**RE: Modification Request - Milne Port Accommodations Camp Upgrade
Water Licence 2AM-MRY1325 – Amend. No. 1**

Attachement 1: Figure 1 from INAC letter dated August 16, 2017

Figure 1: Snapshot of map in Attachment 1 of the modification request showing planned diversion ditch with blue arrows. Streams not coloured blue were added from maps included in the 2017 workplan and 2016 annual report.

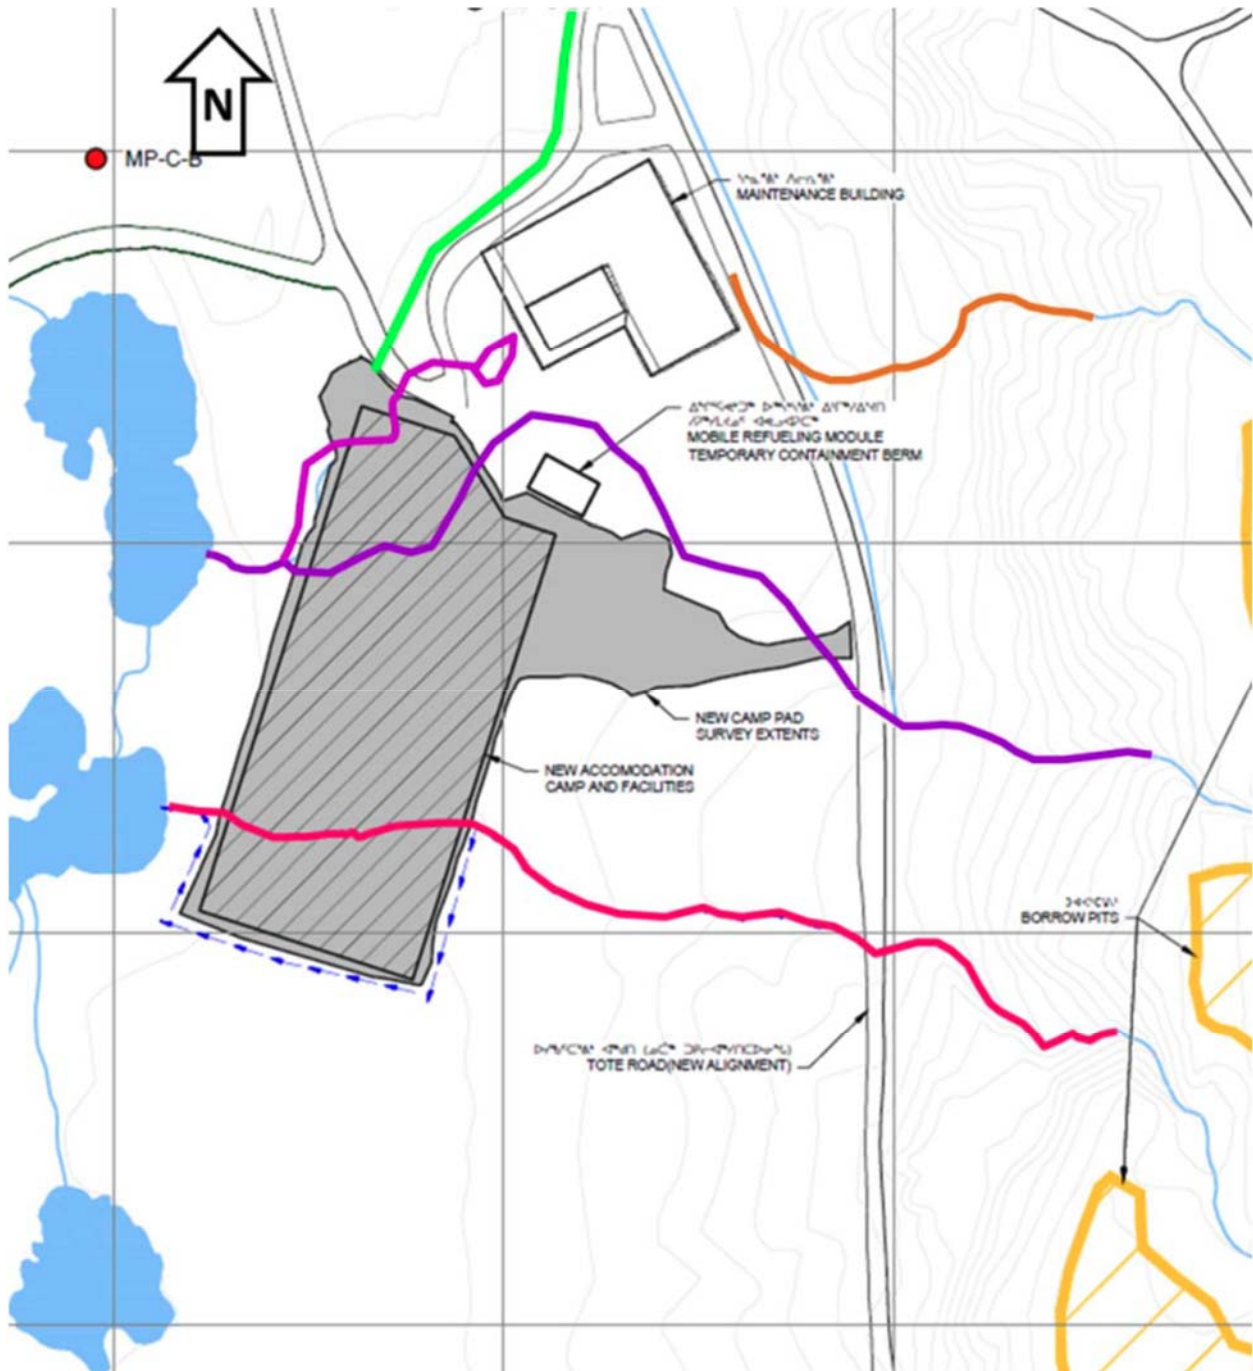
In their comments INAC also indicted a concern regarding water flowing seasonally through a second stream covered by new pad and requested information on how this stream would be managed. The second stream was identified on historical drawings but has been diverted by the road northeast of the proposed pad (diversion ditch is shown as a blue line on the drawings provided by INAC and attached to

this letter) in order to install the already existing laydown area directly northeast of the new pad. No additional diversion structures are required to manage the second stream.
